Assessment Report

DA CP 17-005

**Proposed Coastal Protection Works
46 Arrawarra Beach Road, Arrawarra**

October 2017

Figure 6: Immediate beach erosion hazard predicted for the site

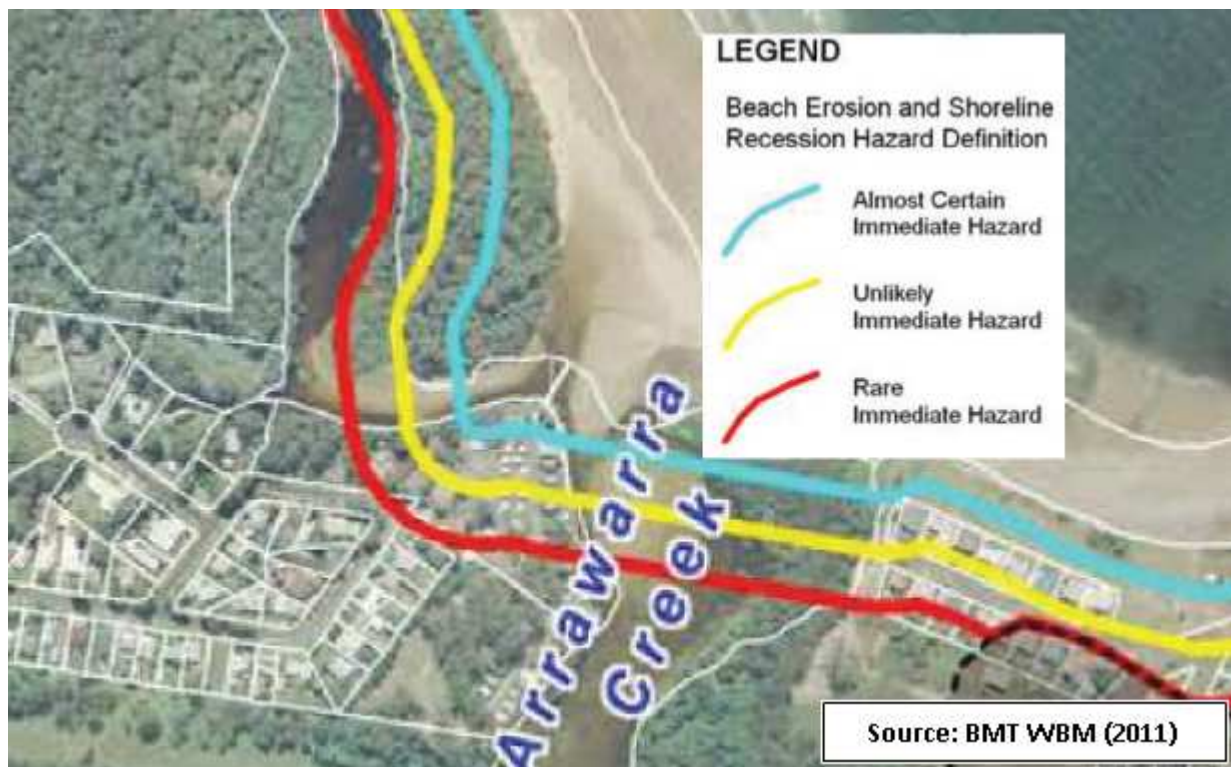
- As is evident in **Figure 6**, below, approximately 90m of the gabion wall is currently exposed to 'almost certain' immediate wave erosion hazard. A length of the gabion wall longer than 90m is potentially impacted, but at a reduced level of likelihood. This description of immediate wave erosion hazard calculated using beach sand losses reinforces the level of scrutiny that should be brought to developing an appropriately conservative design for the revetment wall; and
